**TOWN COUNCIL ACTION ITEM
STAFF SUMMARY
JUNE 5, 2018 TOWN COUNCIL MEETING**

Consideration of Ordinance 03-18, Series of 2018, (second reading and public hearing) reviewing a Level IV Development Application for the Dillon Homewood Suites PUD Development Plan.

**AN ORDINANCE ADOPTING AND APPROVING A PUD
DEVELOPMENT PLAN FOR DILLON HOMEWOOD SUITES**

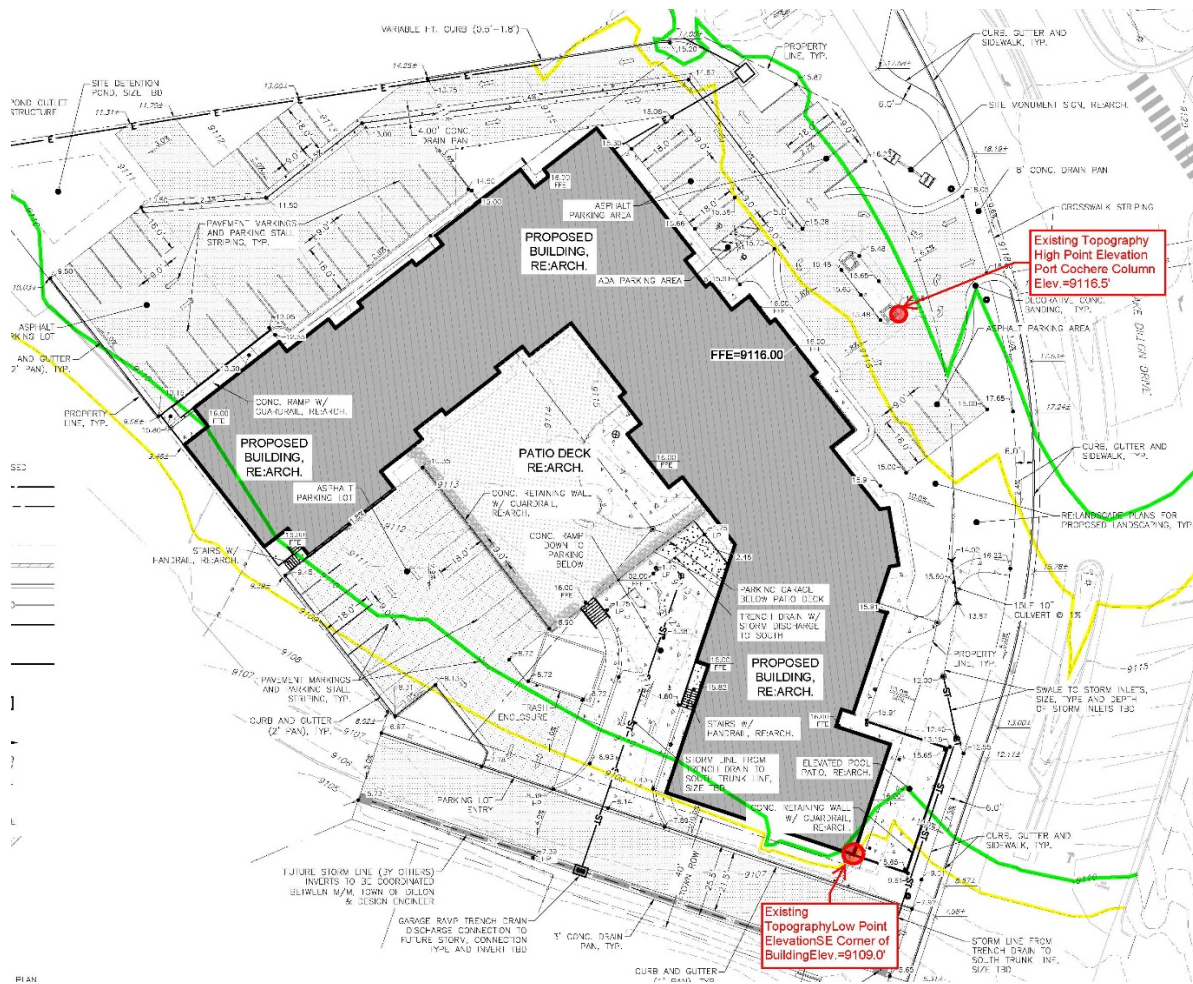
Setbacks may be reduced through the PUD approval process, and the proposed project proposes reduced setbacks from those provided for in the Code. This project will utilize the following minimum setbacks (yards) from the building foundation to the adjacent right-of-way/property:

- Lake Dillon Drive: 0' (Zero lot line)
- 40' Right-of-way: 0' (Zero lot line)
- Lot 2 (Century Link): 0' (Zero lot line)
- U.S. Highway 6: 25'
